NOTICE OF DECISION

DECISION OF THE PLANNING ADMINISTRATOR

URBAN GROWTH PRELIMINARY DECLARATION / CLASS 3 SITE PLAN REVIEW, CLASS 2 ADJUSTMENT / CLASS 2 DRIVEWAY APPROACH PERMIT / CLASS 1 DESIGN REVIEW CASE NO.: UGA-SPR-ADJ-DAP-DR23-01

SUMMARY: A consolidated application to develop a 90-unit multiple family development.

1 SITE PLAN

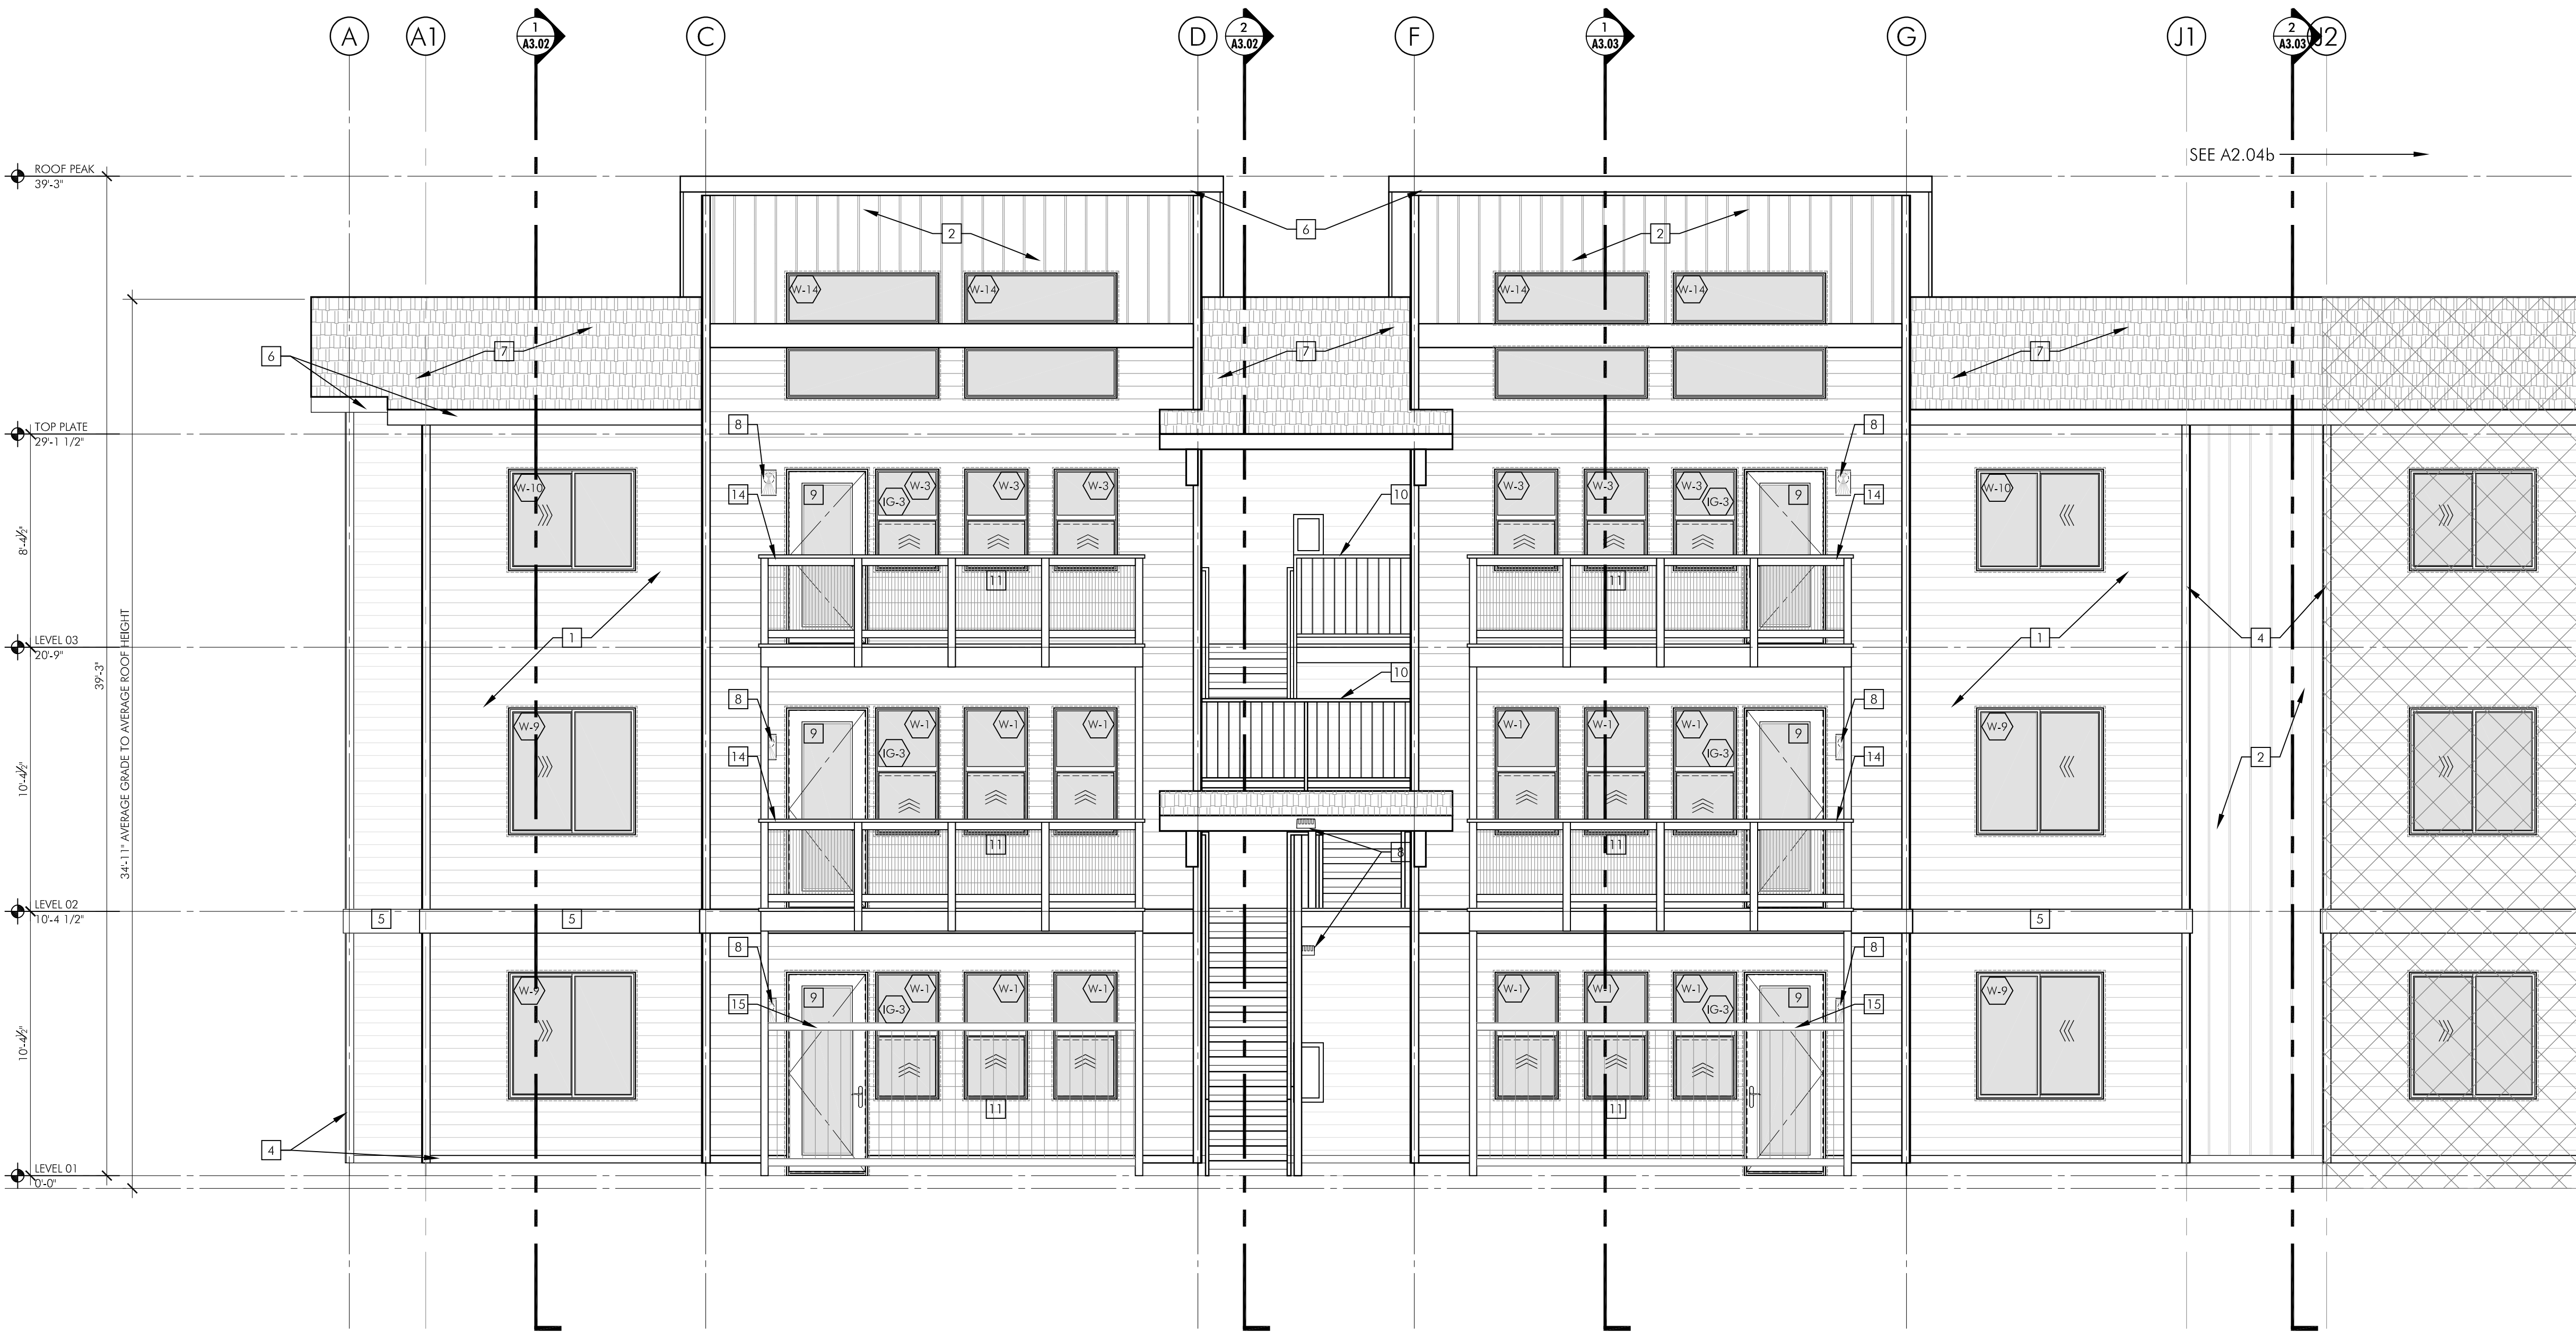
Finding: The total number of units for the proposed multiple family development is 90 dwelling units. The minimum number of off-street parking required is 90 spaces. The site plan indicates a 130 off-street parking stalls are provided, exceeding the minimum off-street parking.

The site plan indicates 47 of the proposed parking spaces are designated as compact. The compact parking space allotment standard set forth in SRC 806.015(b) require the maximum off-street parking stalls proposed for the site not exceed 119 ($90 \times 0.75 = 118.5$).

Finding: The site plan indicates bicycle parking to be with 50 feet of a primary entrance; therefore, this standard is met.

Finding: The site plan indicates inverted style bike racks will be provided. The proposed bike racks conform to material requirements of SRC 806.060(e).

Finding: The site plan indicates that none of the buildings exceed 150 feet. The longest building is 145 feet in length; therefore, meeting this standard.

Condition 1: At the time of building permit review, the applicant shall provide site plan details indicating conformance with SRC800.055(f)(4).
